TOYOTA CUSTOMER SERVICES

Volume: XI
Number: TC04-022
Date: 12/06/2004
 Action
 Retain
 Information

SUBJECT: SPECIAL SERVICE CAMPAIGN (SSC) – 40M
(2004 THROUGH EARLY 2005 MODEL YEAR TOYOTA CAMRY RIGHT FRONT
POWER SEAT, SEAT BELT BUCKLE STATUS SWITCH REPLACEMENT)

SPECIAL SERVICE CAMPAIGN 40M

2. REPLACE THE SEAT BELT BUCKLE SWITCH

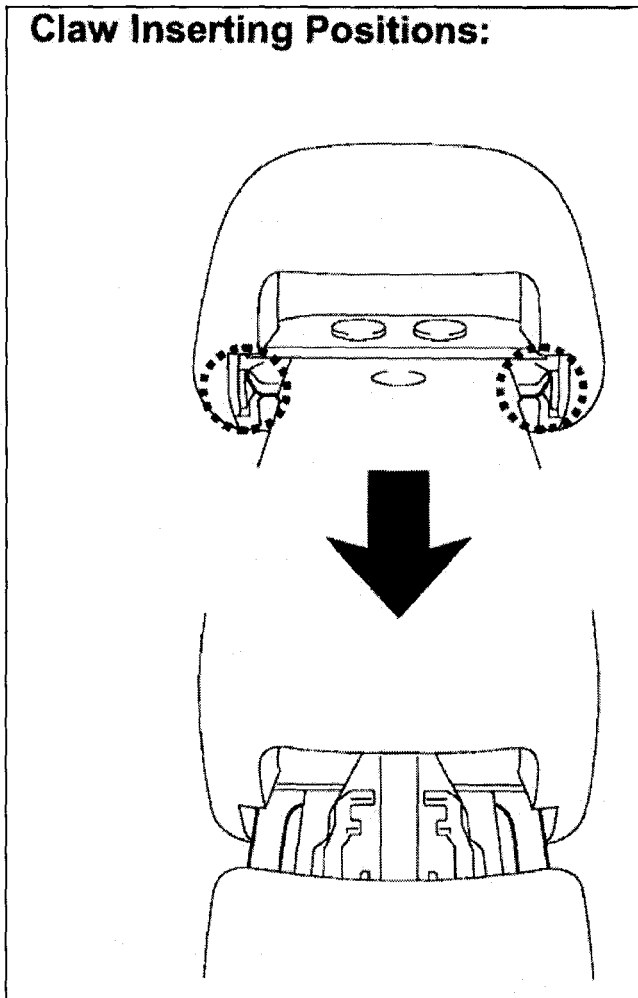
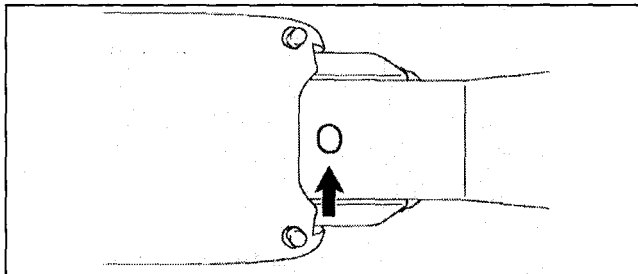
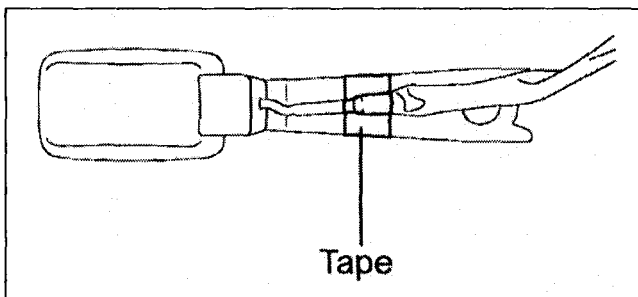
- (d) Using a small pin punch, release the clip holding the switch assembly to the buckle.
- (e) Remove the switch assembly from the buckle.

NOTE:
Pull the switch straight back from the buckle.

- (f) Install the new switch assembly into the buckle.

Ensure that the new switch assembly engages into the buckle. There will be an audible click when the switch is correctly engaged into the buckle.

- (g) Ensure that the tab is securely inserted into the hole in the seat belt buckle.

2. REPLACE THE SEAT BELT BUCKLE SWITCH

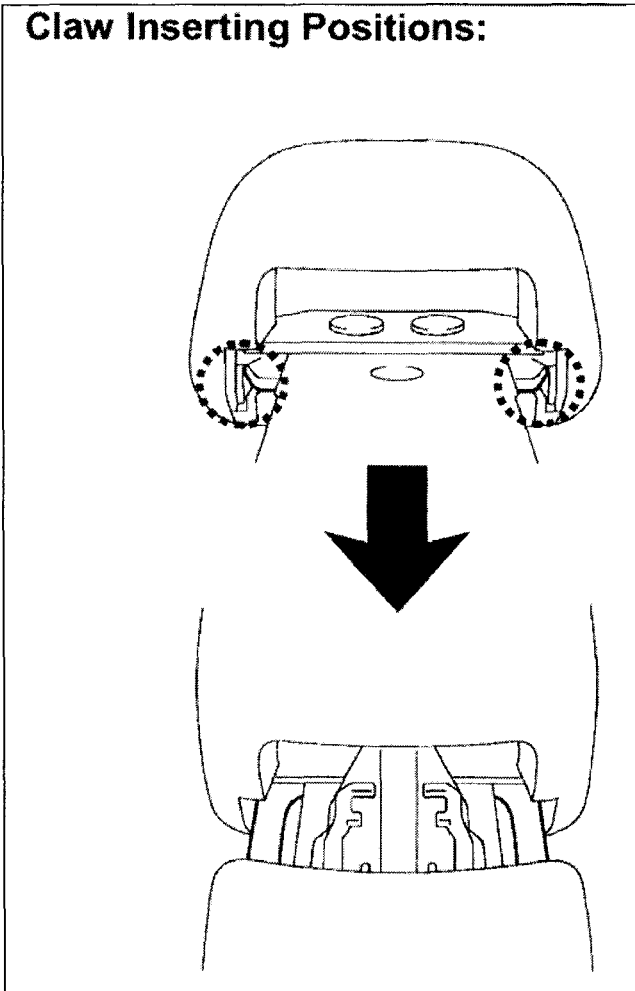
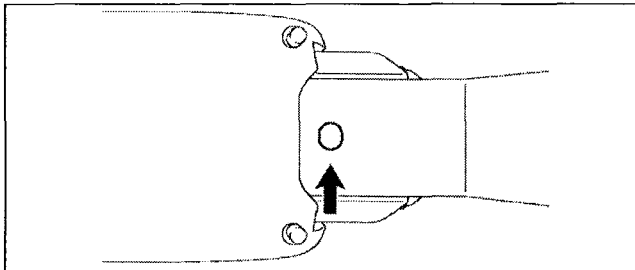
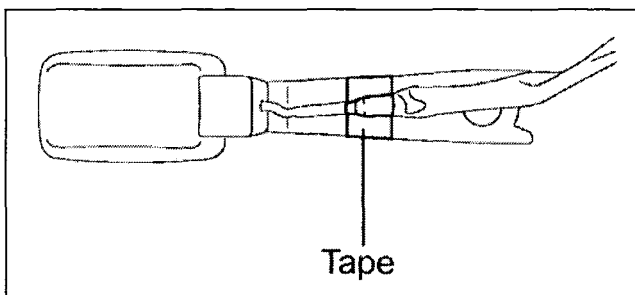
- (d) Using a small pin punch, release the clip holding the switch assembly to the buckle.
- (e) Remove the switch assembly from the buckle.

NOTE:
Pull the switch straight back from the buckle.

(f) Install the new switch assembly into the buckle.

Ensure that the new switch assembly engages into the buckle. There will be an audible click when the switch is correctly engaged into the buckle.

(g) Ensure that the tab is securely inserted into the hole in the seat belt buckle.
